UNITED STATES PATENT AND TRADEMARK OFFICE

APPLICATION NO.	FILING DATE	FIRST NAMED INVENTOR	ATTORNEY DOCKET NO.	CONFIRMATION NO.
10/737,124	12/17/2003	Young-Doug Kim	8947-000074/US	5936
30593	7590	09/22/2008	EXAMINER	
HARNES, DICKEY & PIERCE, P.L.C.			DANG, KHANH	
P.O. BOX 8910			ART UNIT	PAPER NUMBER
RESTON, VA 20195			2111	
			MAIL DATE	DELIVERY MODE
			09/22/2008	PAPER

Office Action Summary

DETAILED ACTION

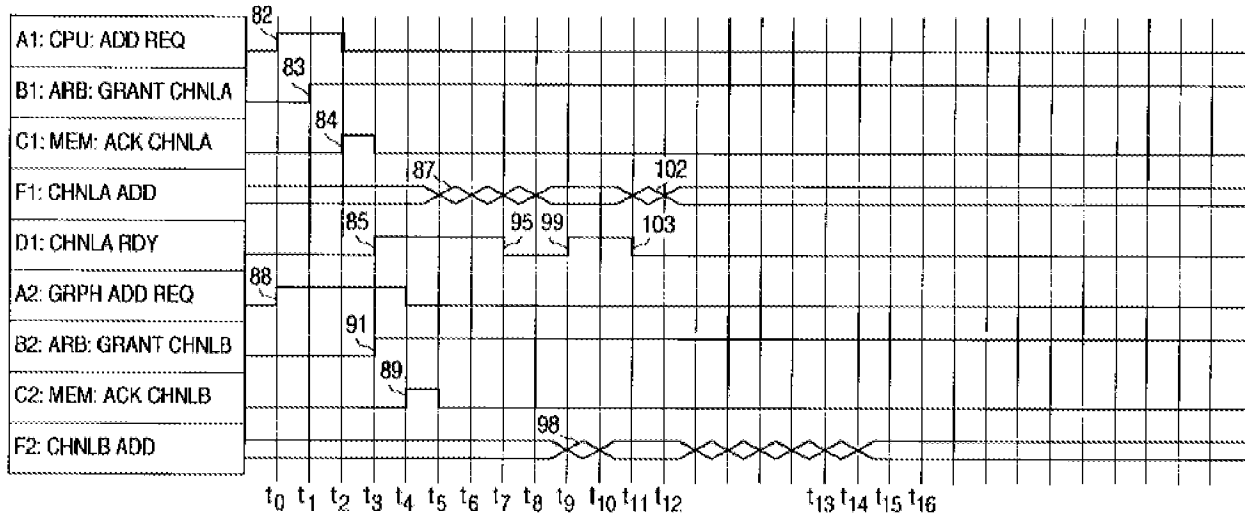
particular, in Kenny, a master module initializes bus access by asserting address and bus request signals on the bus 11. The arbiter 4 and the slave module detect the address and request signals asserted by the master module. The arbiter 4 then identifies the master module making the request, determines the master module's priority, and grants a virtual channel. The virtual channel granted can be arbitrarily selected by an allocation procedure. Specifically, Kenny discloses that "concurrent ownership of the data bus by multiple master/slave pairs advantageously enhances bus accessibility over conventional split-transaction bus protocols since the transactional overhead associated with bus re-acquisition protocols between a master/slave pair is eliminated. Since each channel, hence each master/slave pair, has its own unique channel active signal, data transfer between the master/slave pair commences immediately upon the arbiter asserting the appropriate "channel active" signal." Kenny further discloses that "FIG. 9 is a timing diagram summarizing concurrent transactions of three virtual channels of the present invention." In addition, Kenny discloses that "[a]ll concurrent virtual channel owners wait for an access grant by arbiter 4 to data bus 2. Access to data bus 3 to a particular virtual channel occurs when arbiter 4 asserts the virtual channel's active signal (e.g., CHNLA ACTIVE). Note that in Fig. 9, because the priority of each requesting master (CPU, PCI Controller, Graphics Controller) is not pre-assigned, the arbiter 4 must resolve the priority between requesting masters, and grants virtual channels A, B, C to each requesting master based on priority of each requesting master, by asserting signal GNT CHLNA, signal GNTCHLNB, and signal GNTCHLNC, at times t1, t3, and t5. Fig. 9 is reproduced below:

Kenny also discloses that the arbiter receives transaction information from all requesting master units in response to the pseudo-grant signals (after asserting signal GNT CHNLA, arbiter 4 returns to its initial state 47 to wait for the next ADD/REQ signal from each of the requesting master).

Although Kenny clearly disclose that pseudo-grant signals are generated to all the requesting masters. Kenny, as discussed above regarding Fig. 9, does not particularly disclose that the pseudo-grant signals begin at the same time, as claimed in at least Applicants' claim 1, and shown in Fig. 6, which is reproduced below:

Fig. 6

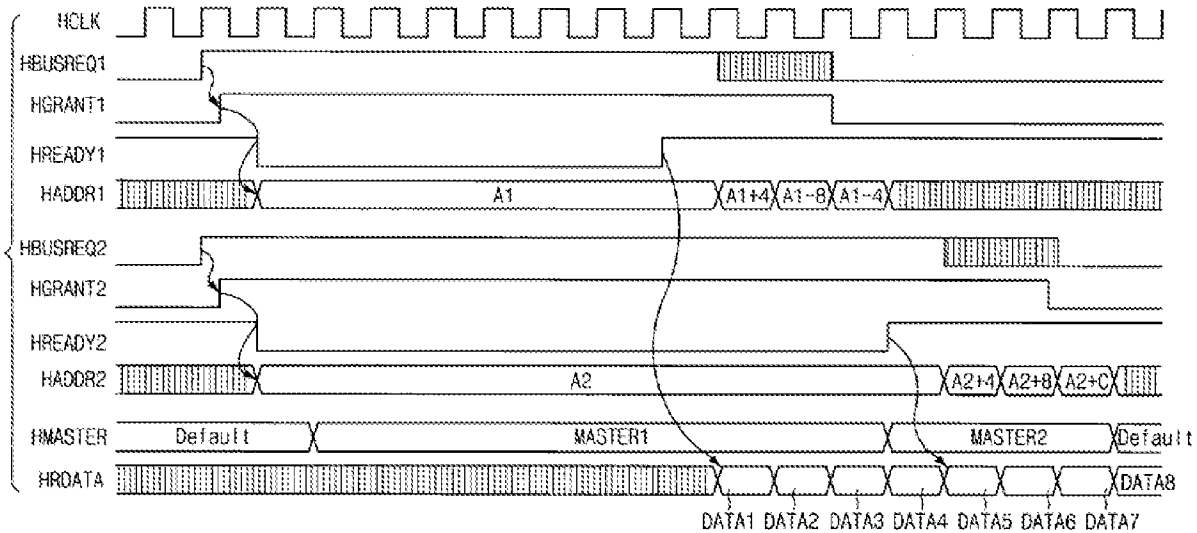
Note that in Fig. 6 above, the pseudo-grant signals HGRANT1 and HGRANT2 begin at the same time.

Fig. 6

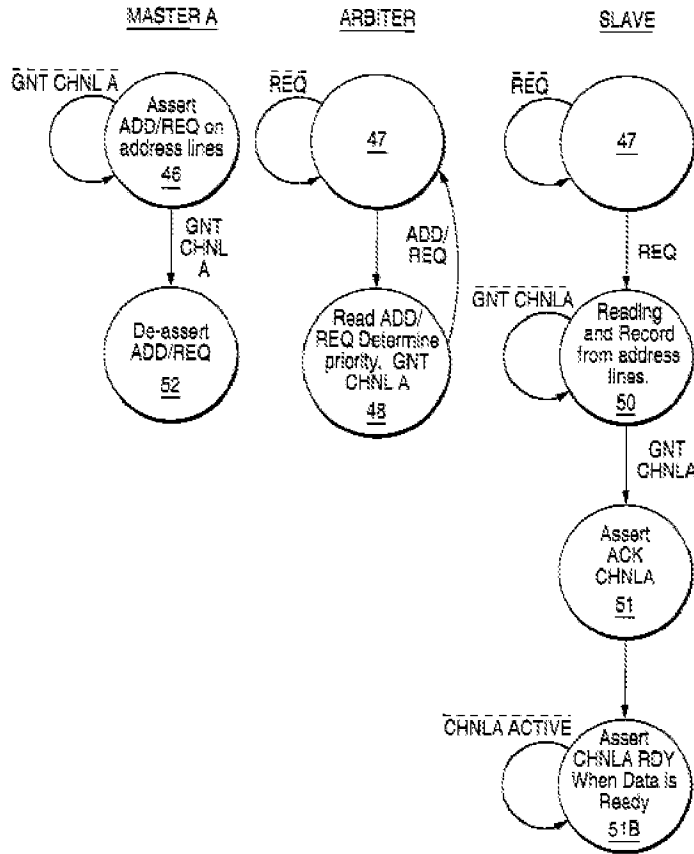
Appellants have also argued that "[r]eferring to FIG. 6 of Kenny, upon detecting the ADD/REQ signal from the master module A, the arbiter 4 asserts grant channel A signal GNT CHNLA on address bus 3 to assign a virtual channel to master module A. Kenny at 7:34-7:37. After transmitting the virtual grant channel A signal GNT CHNLA, arbiter 4 returns to its initial state 47 to wait for the next ADD/REQ signal.

Id. at 41-42. But, the next ADD/REQ signal received by the arbiter 4 is independent or- not in response to - the grant channel A signal GNT CHNLA signal from the arbiter 4. Thus, contrary to claim 1, the arbiter 4 issues a virtual channel grant (grant channel A signal) GNT CHNLA in response to a ADD/REQ signal from a master module 4, but does not receive 'transaction information from all requesting master units in response to the pseudo-grant signals.'"

Contrary to Appellants' argument, it is clear from Kenny, particularly Fig. 6, which is reproduced below for ease of reference and convenience, and discussion above that the next ADD/REQ is not independent. As a matter of fact, the next ADD/REQ would not be sent to the master if the GNT without reception of the GNT signal. In other words, ADD/REG (transaction information) from requesting masters is sent to the arbiter in response to the pseudo-grant signals.
